2014 - 2018 Corvette: Service Bulletin: #PIP5248D: Stalling Shudder And/or Hard shifting Into 1st Gear Or Reverse Vibration On launch

#PIP5248D: Stalling Shudder And/or Hard shifting Into 1st Gear Or Reverse Vibration On launch (With Excessive Crankshaft End Play) - (Aug 10, 2017)

This PI was superseded to update Models. Please discard PIP5248C.

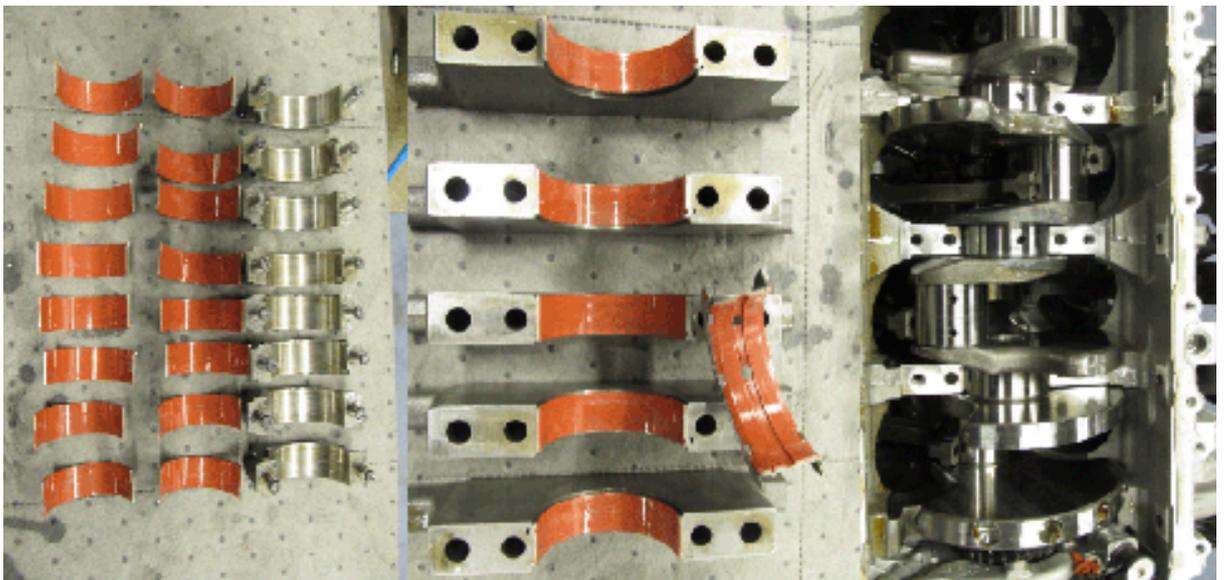
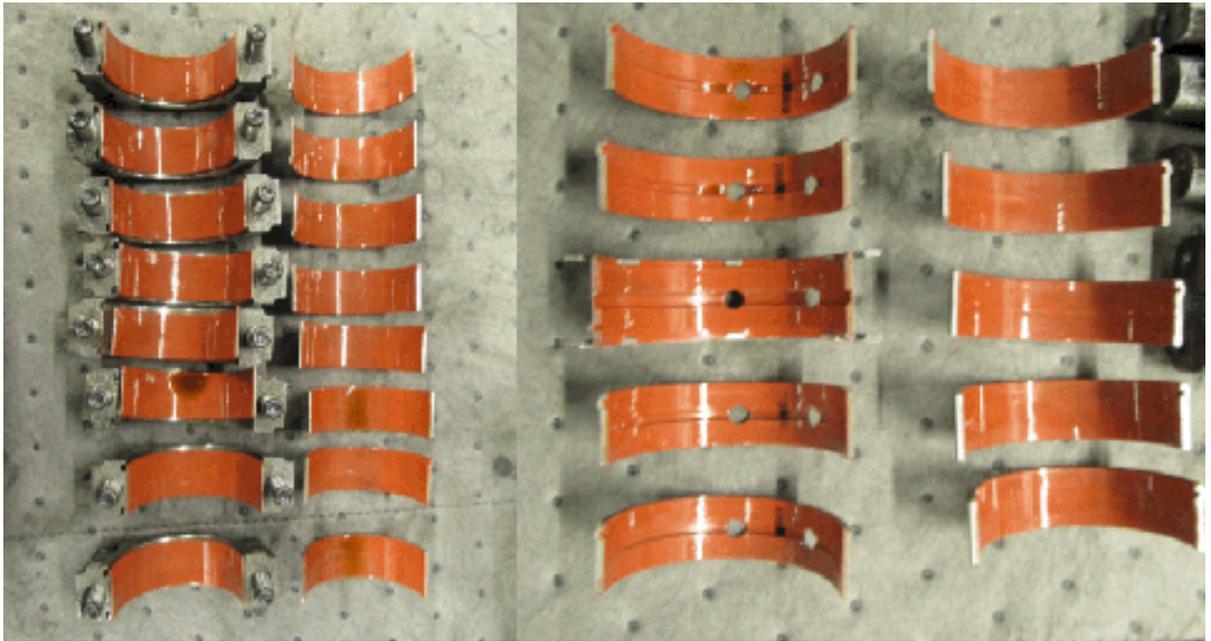
This concern could be caused by excessive crankshaft end play.

Check to determine if the crank shaft end play is within specification 0.0015–0.0086 in (0.040–0.220 mm). See eSI.

If end play is found to be out of specification, remove engine and inspect for possible Crankshaft thrust bearing and/or crankshaft for wear.

Note: If bearings and crankshaft look like components in attached picture, damage has not occurred.

Inspect thrust bearing for wear on one side and crankshaft on that “mating” surface.

If wear is evident (3 vertical channels worn off) replace connecting rod bearings, main bearings, thrust bearing and crankshaft.

For this repair the oil tank with lines and oil cooler are both required to be replaced if equipped.
